# TOWN OF FAIRFAX STAFF REPORT

**TO:** Fairfax Planning Commission  
**DATE:** November 19, 2020  
**FROM:** Linda Neal, Principal Planner  
**LOCATION:** 5 Woodland Road; Assessor's Parcel No. 003-053-10  
**PROJECT:** Single-family residence and garage  
**ACTION:** Hill Area Residential Development, Design Review, Excavation, Encroachment, Tree Removal and Variance Permits; Application # 20-11

**5 WOODLAND ROAD**

**A Resolution of the Fairfax Planning Commission Approving Application No. 20-11 for a Hill Area Residential Development Permit, Excavation Permit, Encroachment permit, Tree Permit, and Design Review Permit for a Residence at 5 Woodland Road**

VEGETATION MANAGEMENT PLAN

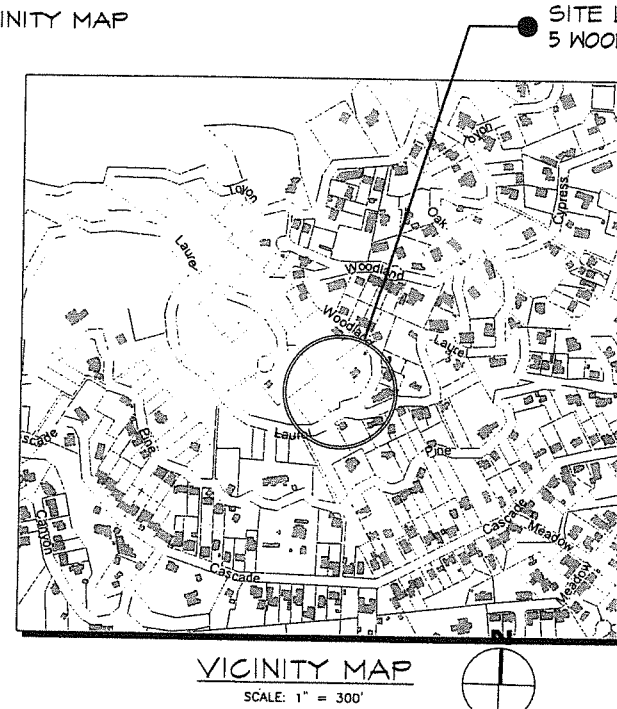
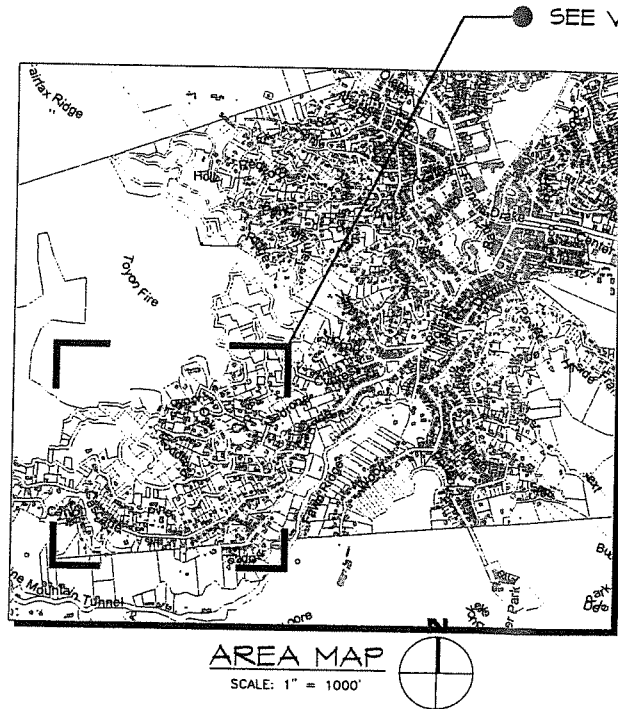
The Ross Valley Fire Department has approved a vegetative management plan (VMP) (the VMP is sheet 20 of the project plans and is signed "approved" by the RVFD).

Prior to submittal of the building permit the applicants shall have the project arborist provide the Town with an assessment of the trees being removed for fire protection to determine if their removal is necessary for fire safety making every effort to retain as many healthy trees as possible outside the construction zone. If the report results in trees being preserved that are shown to be removed in the RVFD-approved VMP, the applicants shall obtain an approved revised VMP plan from RVFD prior to issuance of a building permit. The protection measures indicated in the existing report shall apply to all the trees being retained in the final assessment that may be impacted by the construction.

preserved that are shown to be removed in the RVFD-approved VMP, the applicants shall obtain an approved revised VMP plan from RVFD prior to issuance of a building permit. The report shall include recommendations for tree protection during and after construction, to be included as conditions of approval.
